**FINAL DRAINAGE REPORT  
FOR  
YODER ELECTRIC SUBSTATION  
EL PASO COUNTY, COLORADO**

Prepared For:  
**MOUNTAIN VIEW ELECTRIC ASSOCIATION**  
David Waldner  
11140 E Woodmen Rd, Peyton, CO 80831  
(719) 495-2283

Prepared By:  
**TERRA NOVA ENGINEERING, INC.**  
721 S 23<sup>rd</sup> Street  
Colorado Springs, CO 80904  
(719) 635-6422

Job No. 1802.00

# DEVELOPED DRAINAGE MAP

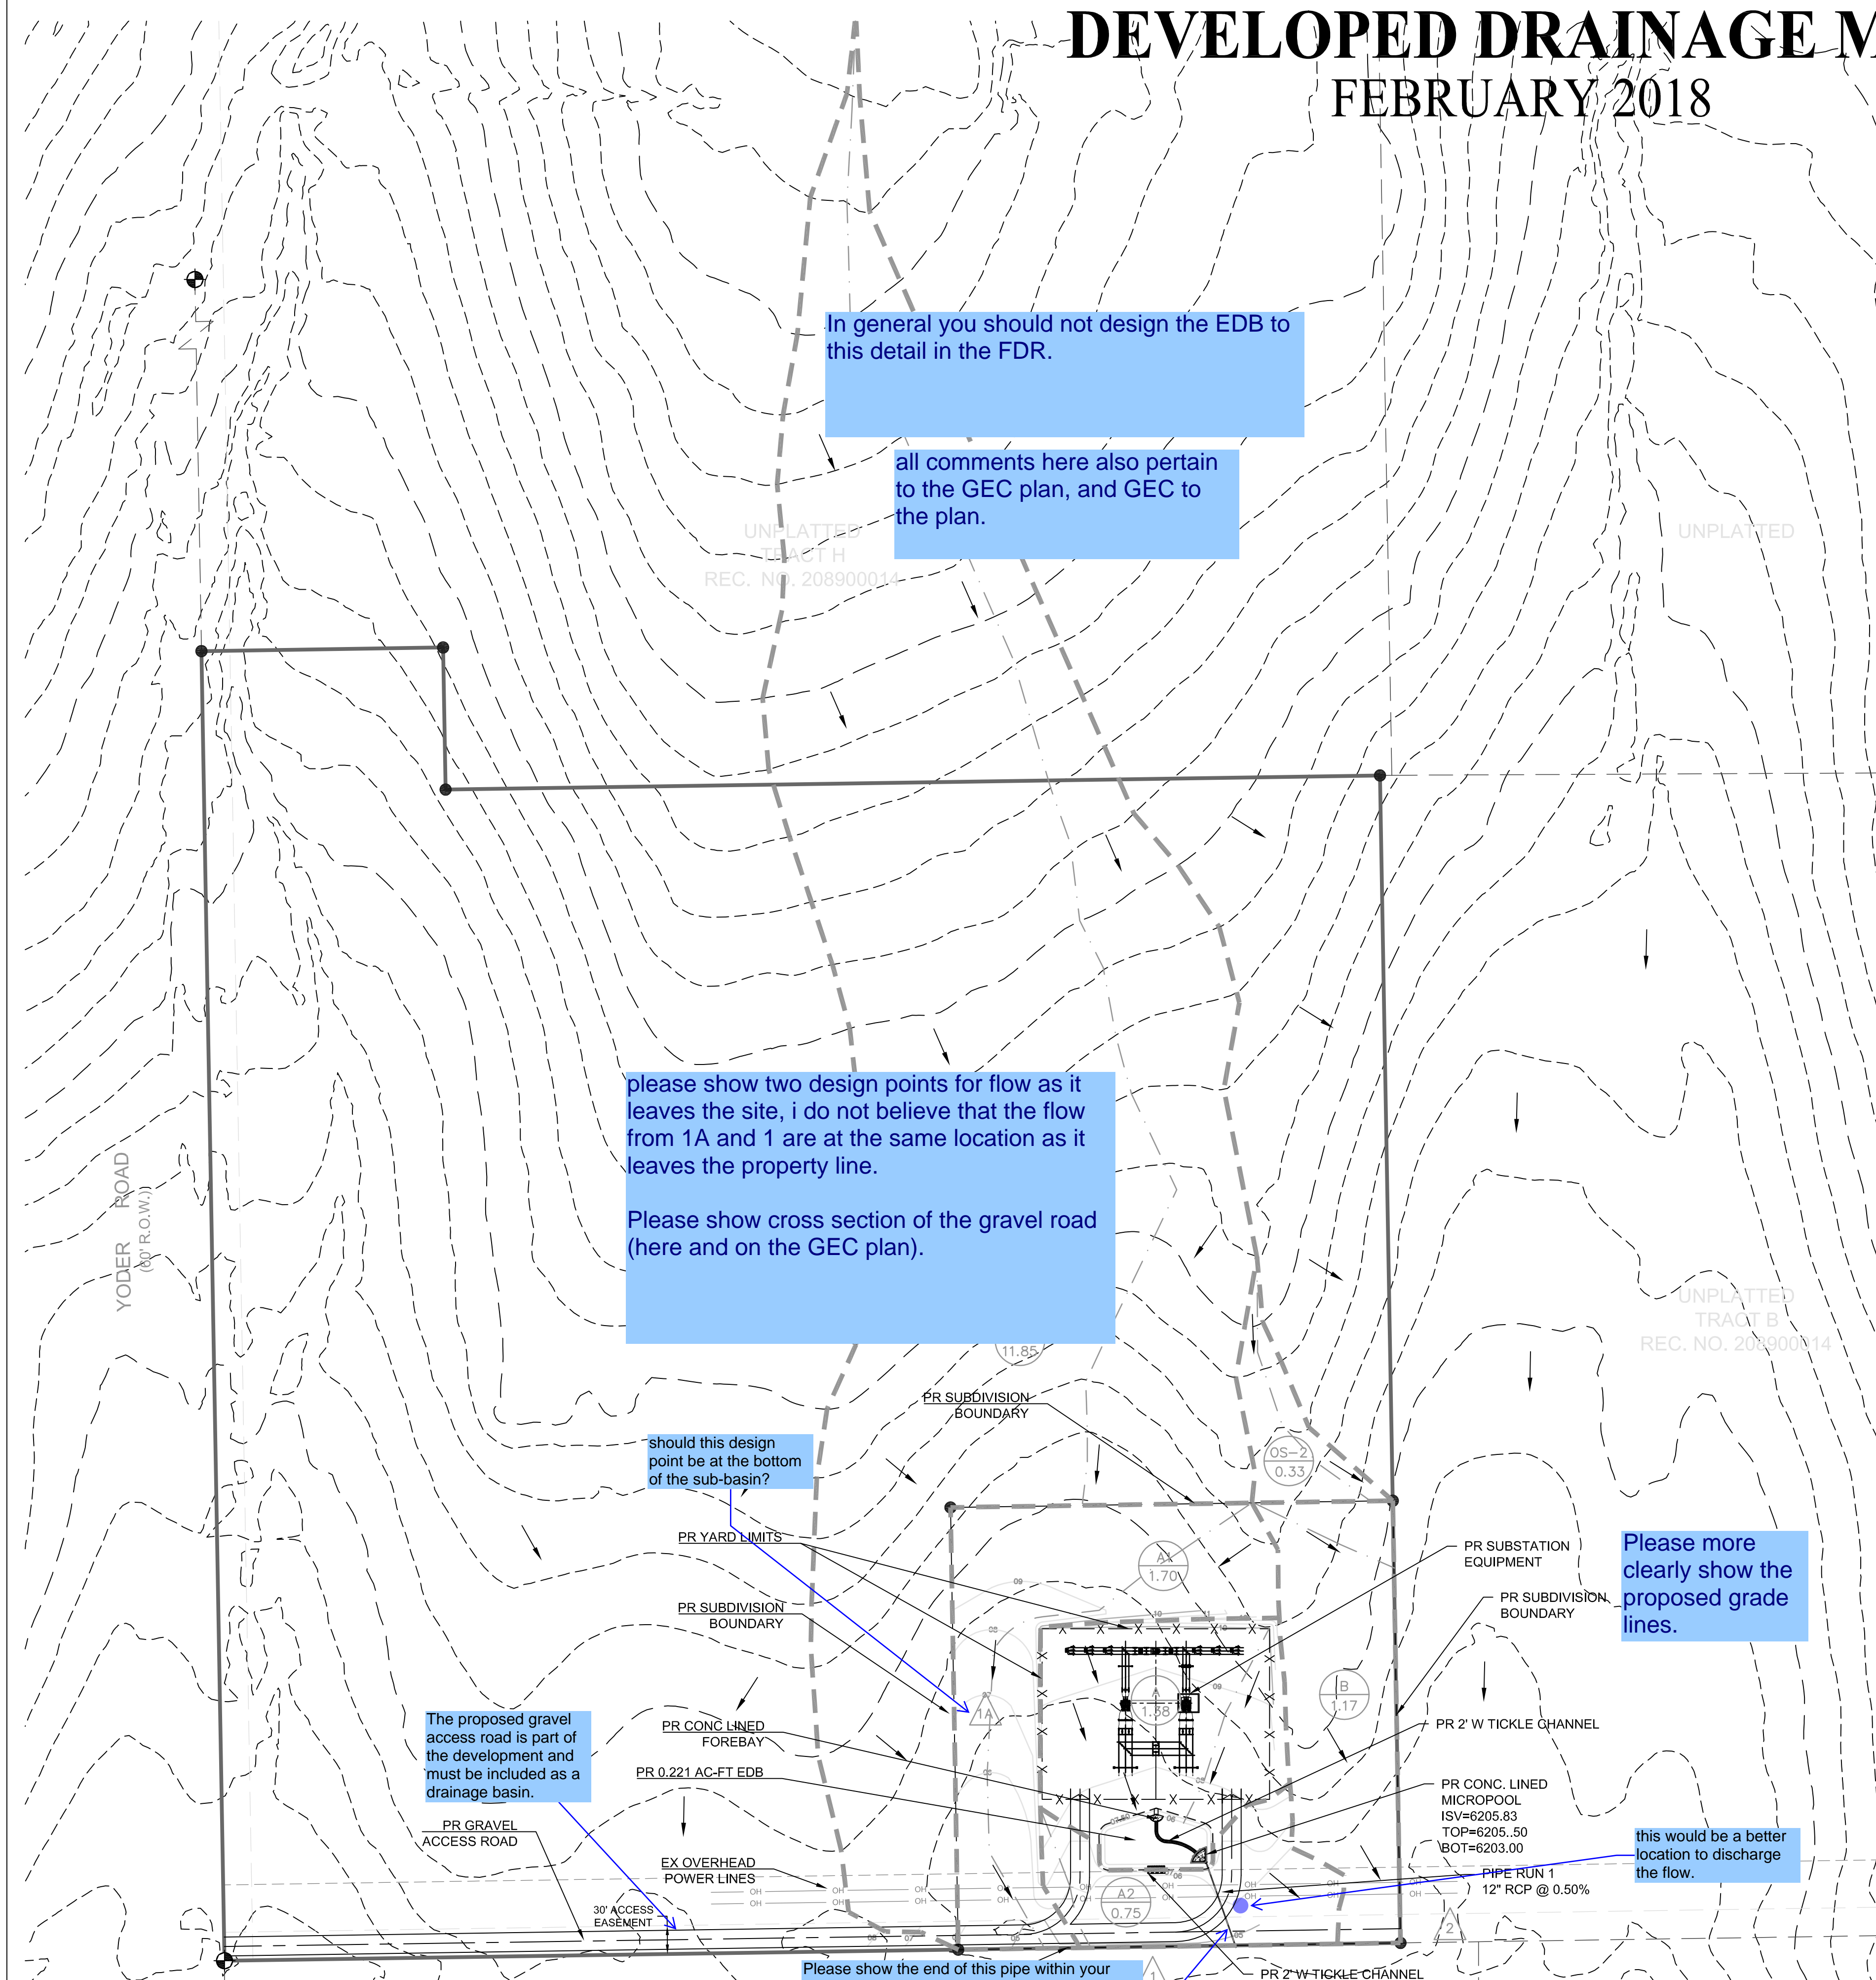
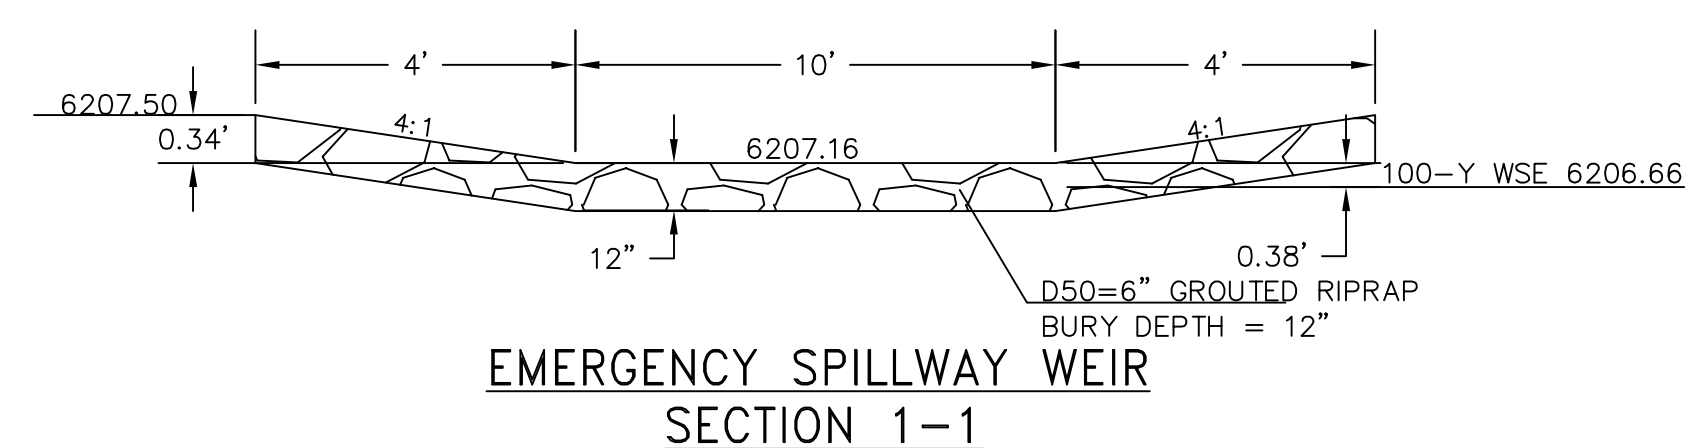
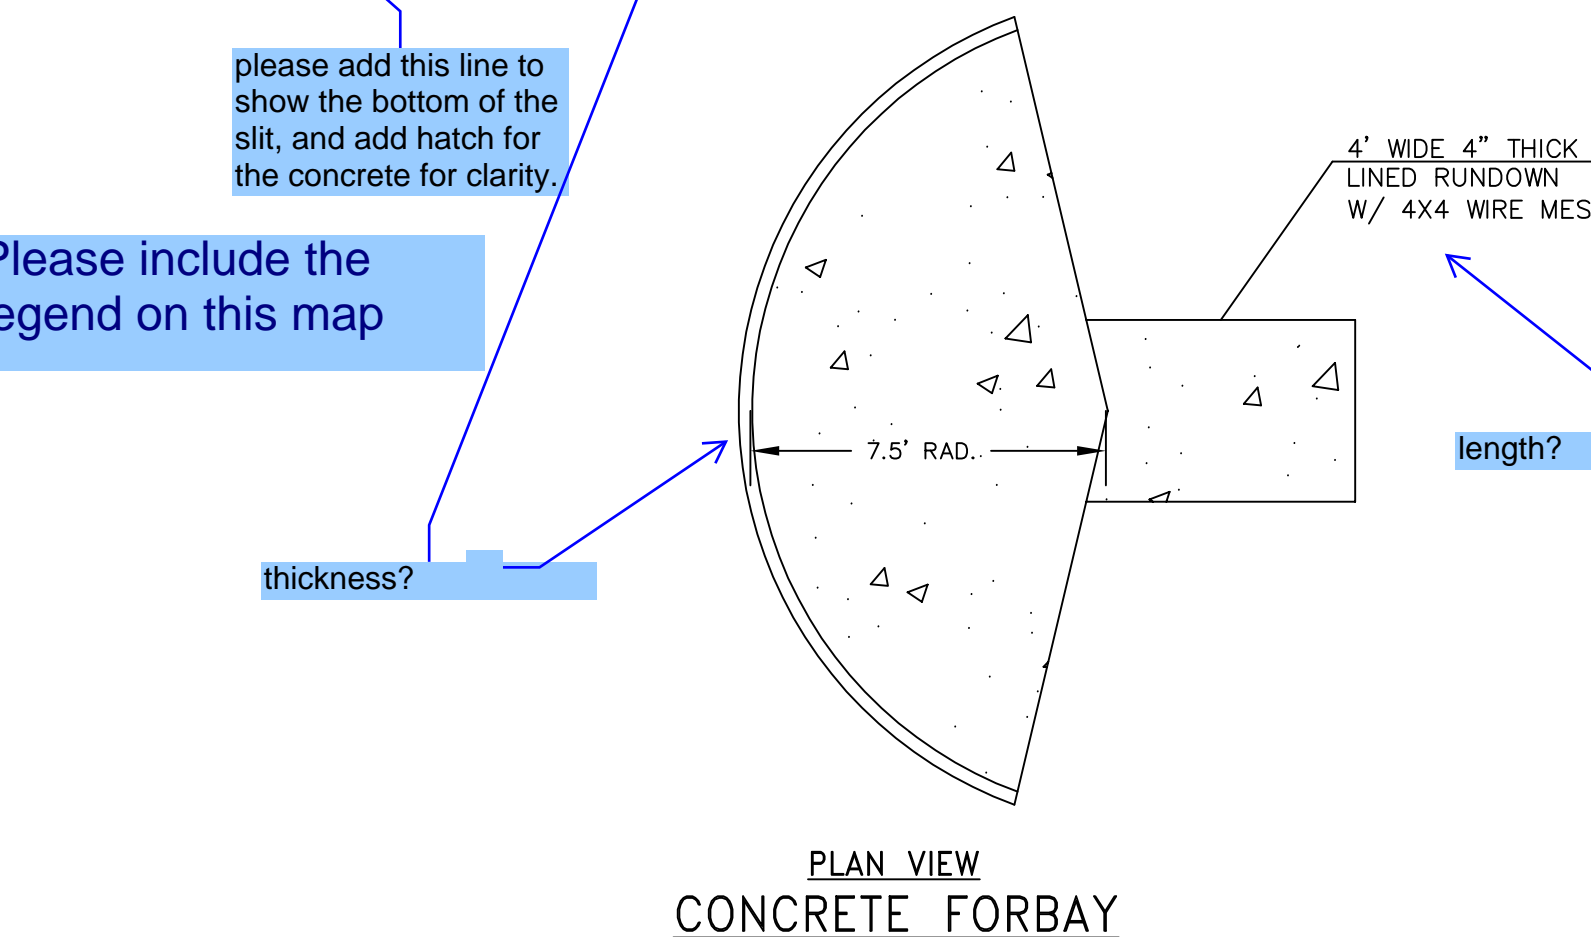
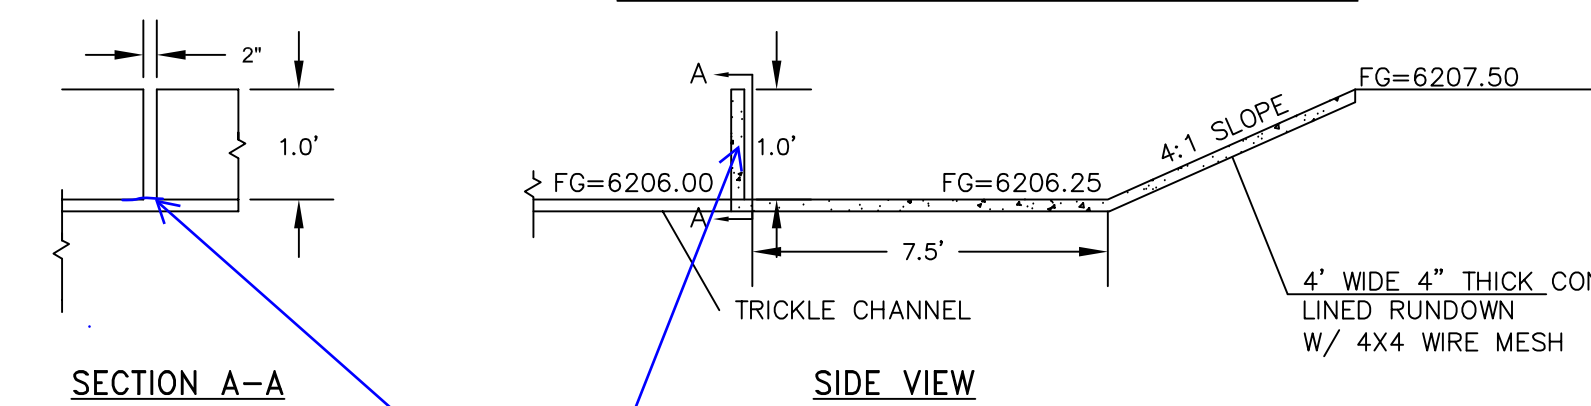
please show two design points for flow as it leaves the site, i do not believe that the flow from 1A and 1 are at the same location as it leaves the property line.

Please show cross section of the gravel road (here and on the GEC plan).

Please more clearly show the proposed grade lines.

The proposed gravel access road is part of the development and must be included as a drainage basin.

Please show the end of this pipe within your property, as well show FES, erosion protection, and how you intend to spread the flow to avoid damage to adjacent property.

Is this a typo and should be called out as the spillway? if so, please correct.

# EXISTING DRAINAGE MAP

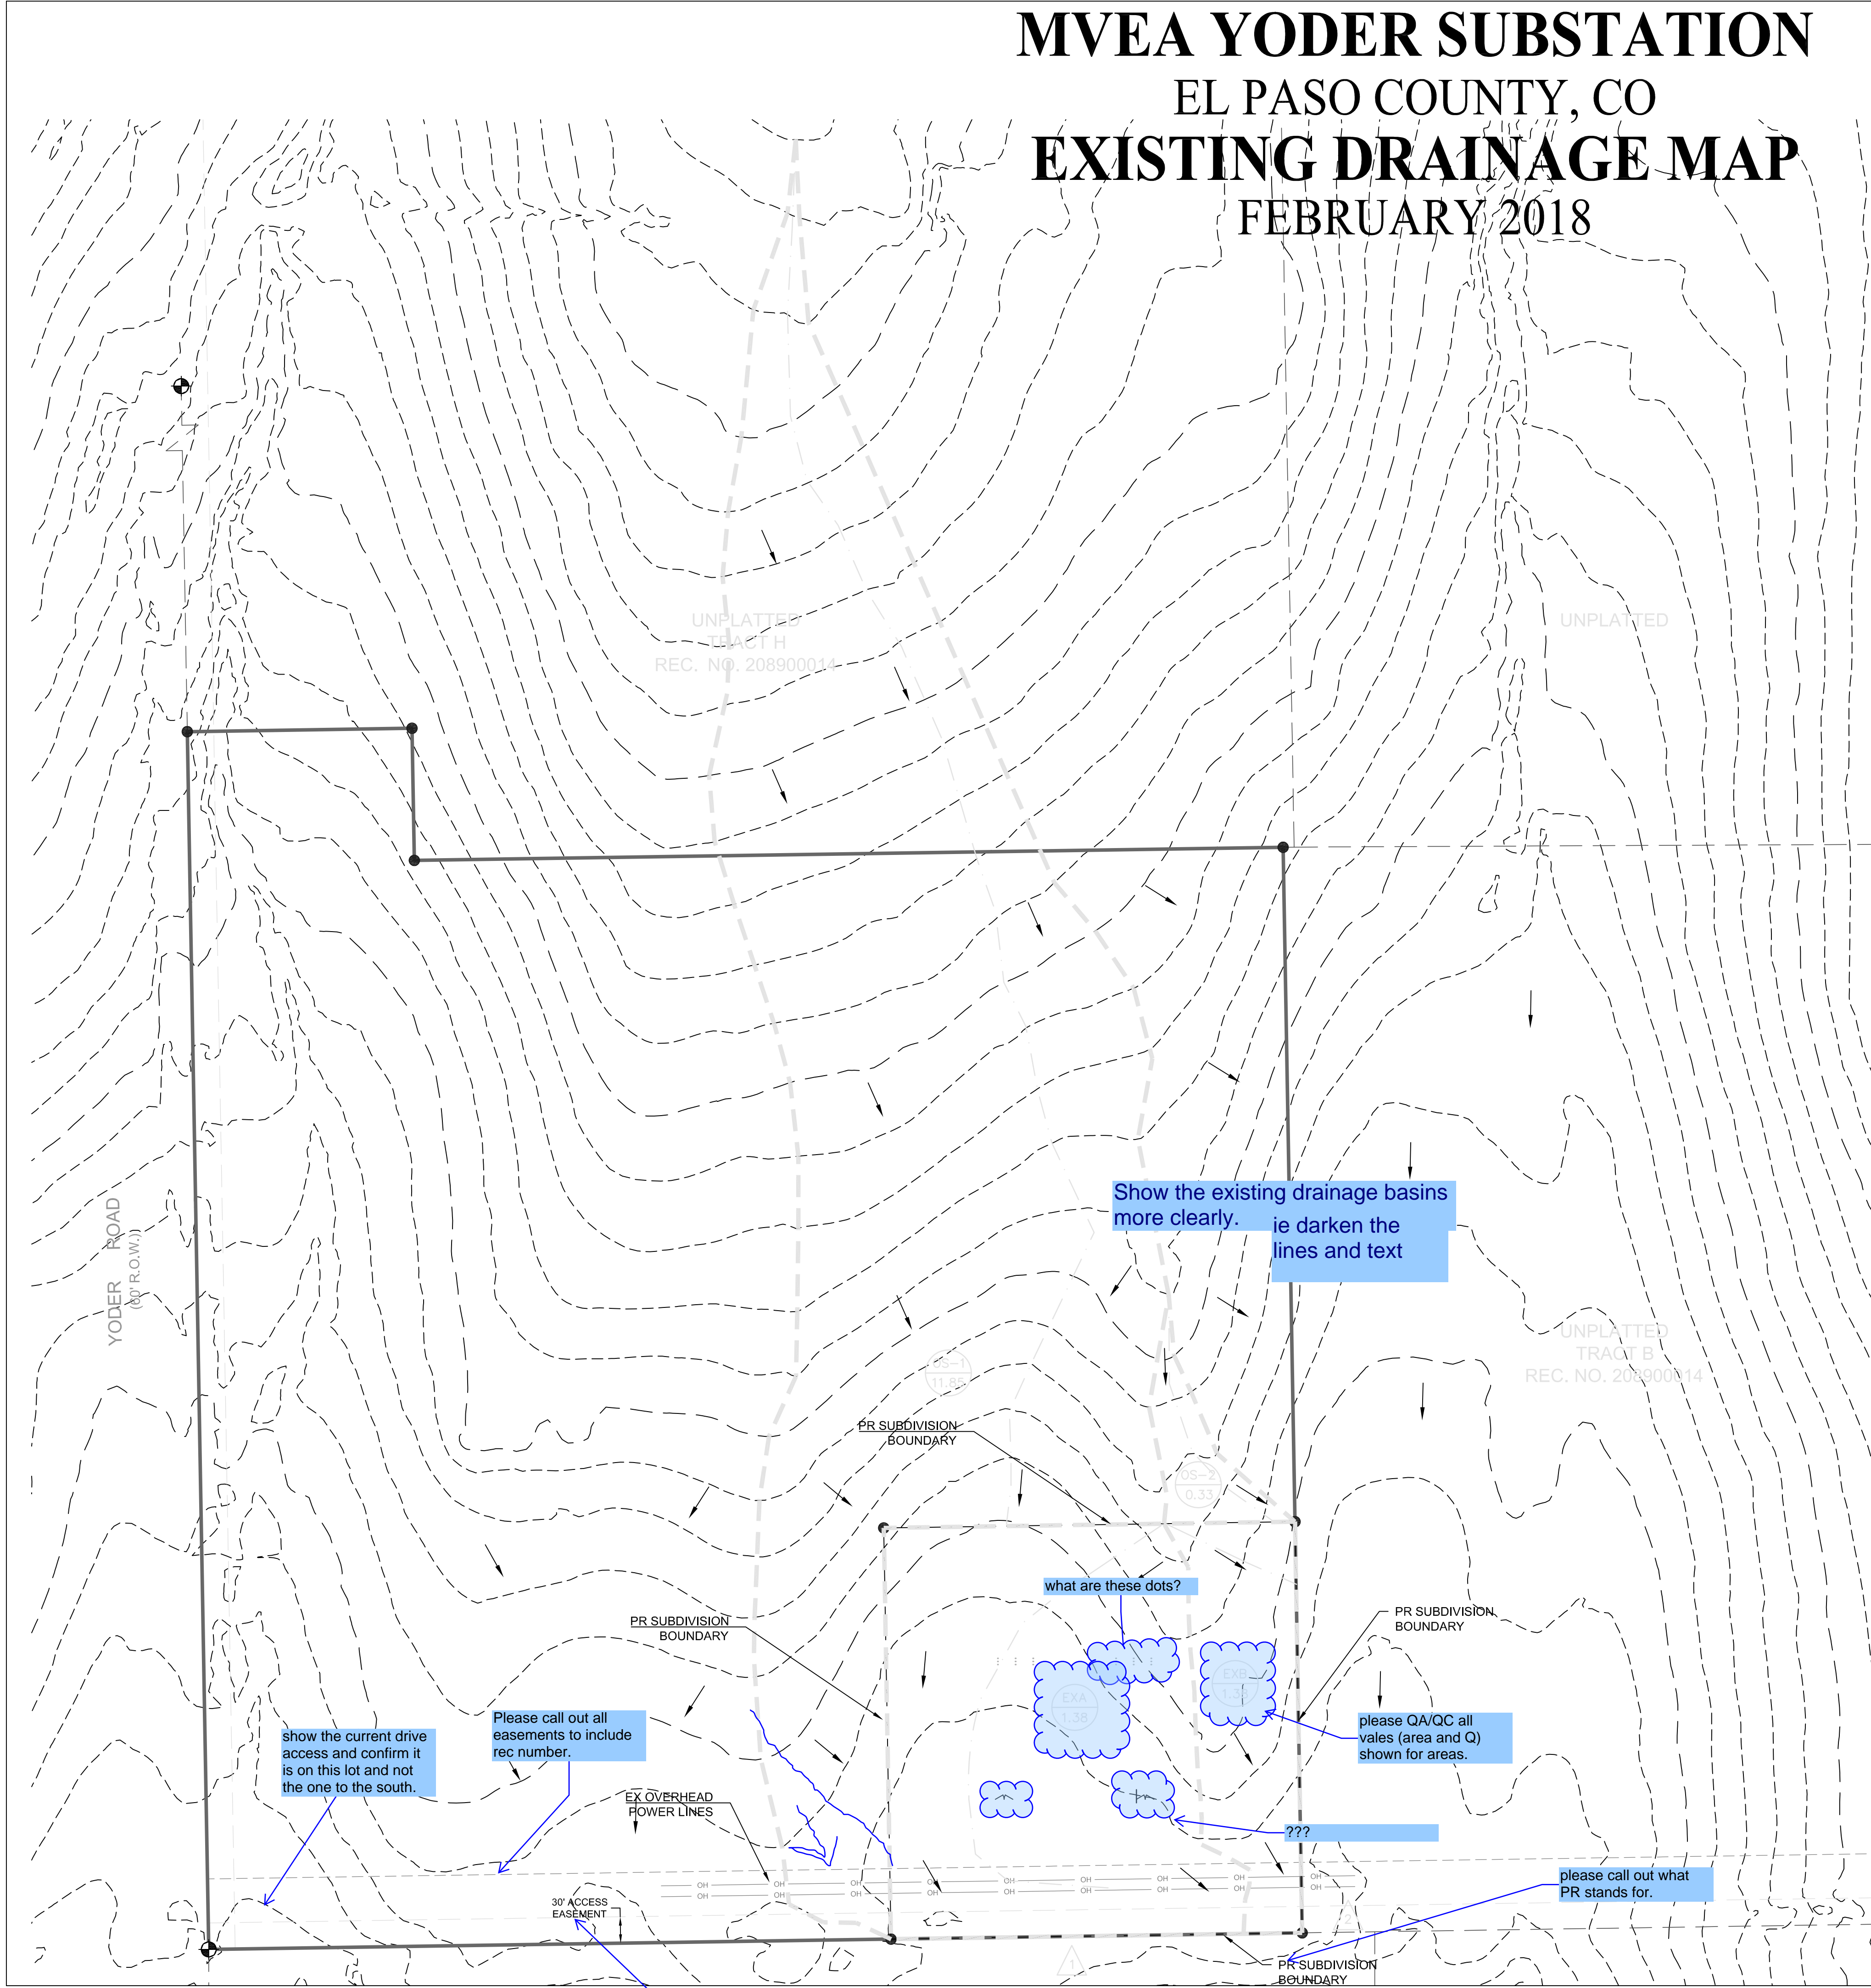
show the current drive access and confirm it is on this lot and not the one to the south.

Please call out all easements to include rec number.

proposed or existing? please provide rec number.

Show the existing drainage basins more clearly. i.e. darken the lines and text

what are these dots?

please QA/QC all vales (area and Q) shown for areas.

please call out what PR stands for.

call out all adjacent property owners.
